Claimant: Robert Chambers

Water Right(s): 33-07009, 33-07025, 33-07065

STATE OF IDAHO
DEPARTMENT OF WATER RESOURCES
ADJUDICATION CLAIM VERIFICATION REPORT

AJ0749NP
No. R33-07025

Looking East from

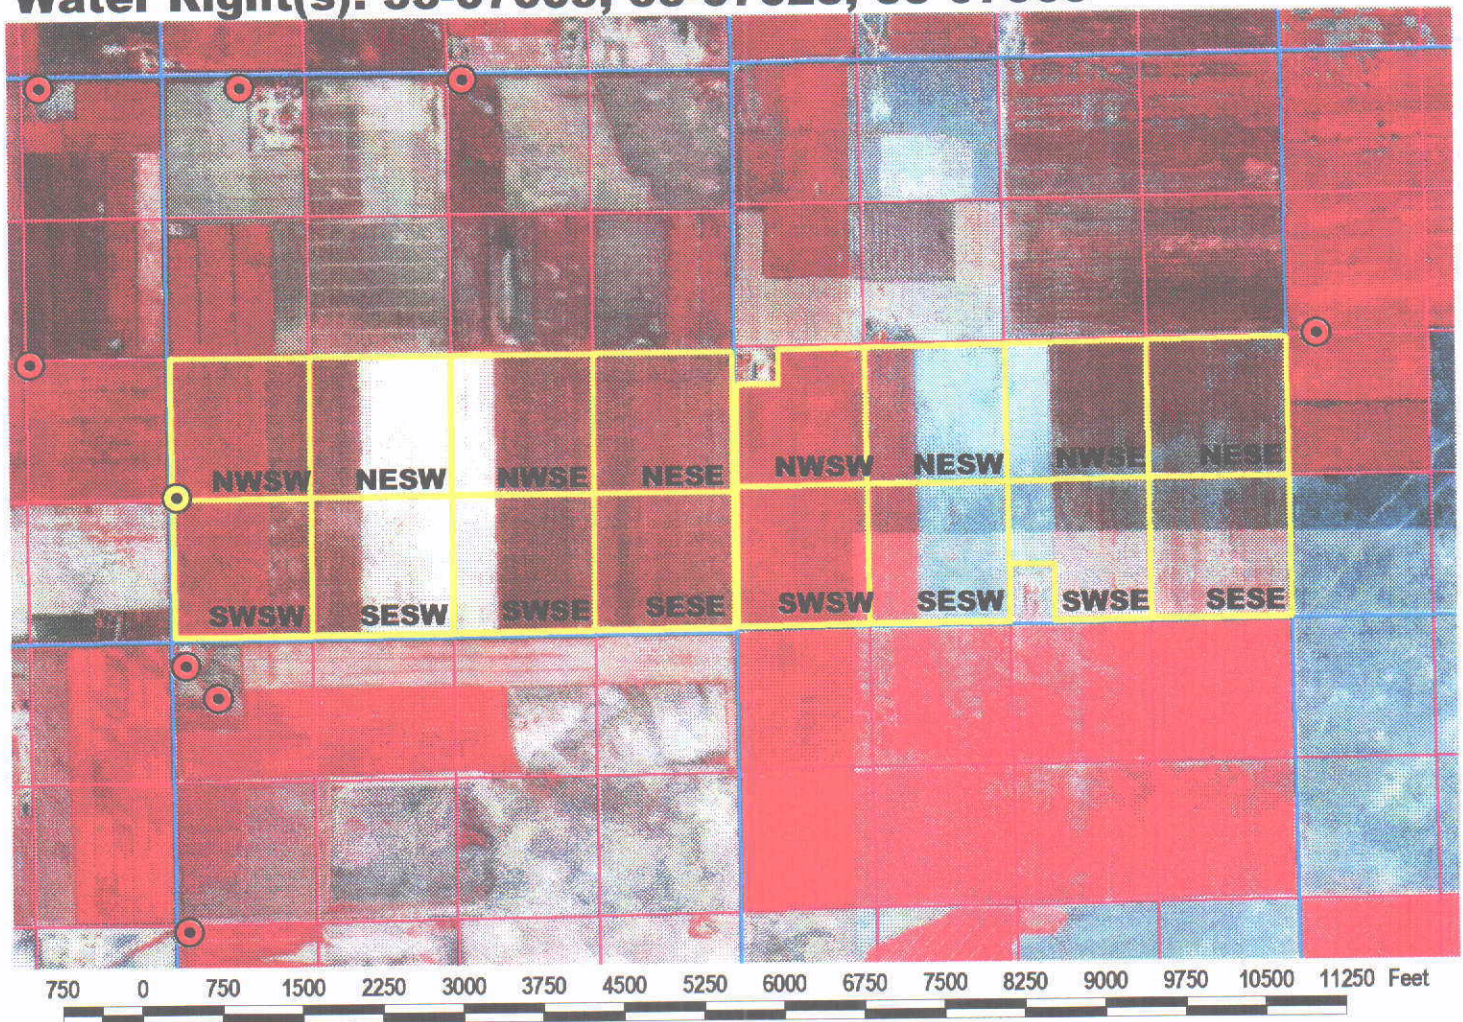
See field notes in CVR for A33-07065.

Looking East

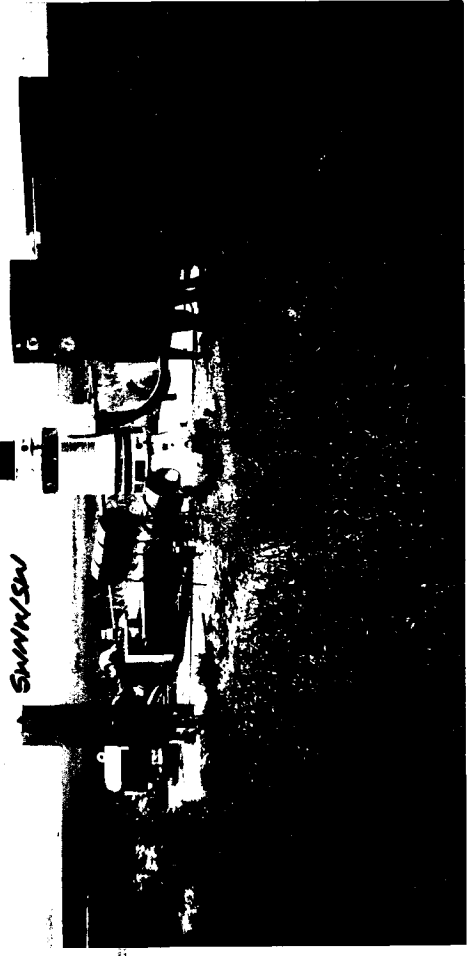
See field notes in CVR for A33-07065.

See CVR for A33-07009. Complete overlap of A33-07009. Also, because this claim is on the same irrigation system as A33-07065, it may be possible to recommend A33-07009, A33-07025, and A33-07065 in a permissible place of use scenario.

Place of use verified by field exam 7-19-94. S.W. Keen
